Customer Service Bulletin Commercial Business Group

GREENSMASTER® 3200/3200-D Cutting Units

Subject: Availability of performance improvement kit for cutting units.

Improved Front Shield with Larger Retaining Spring Clips.

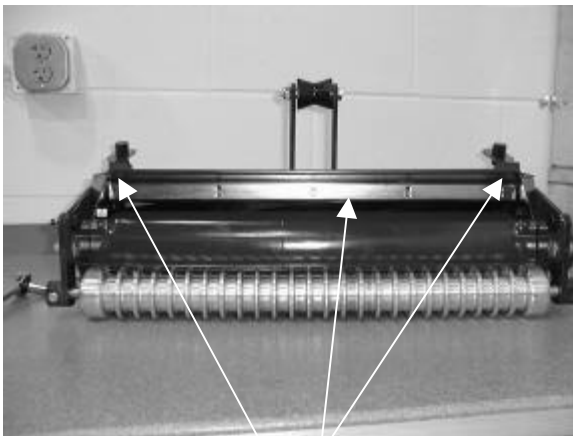
- 1) Replacement Rear Shields with an adjustable cutoff bar and deflectors for better throw characteristics.
- 2) Replacement Front Shields with a smoother profile and larger retainer clips for less clumping and to upgrade the retainers to a more durable design.
- 3) Grease Sleeves that can be installed inside the Rear Rollers to make maintenance easier by reducing the volume of grease required for filling the bearing cavities.
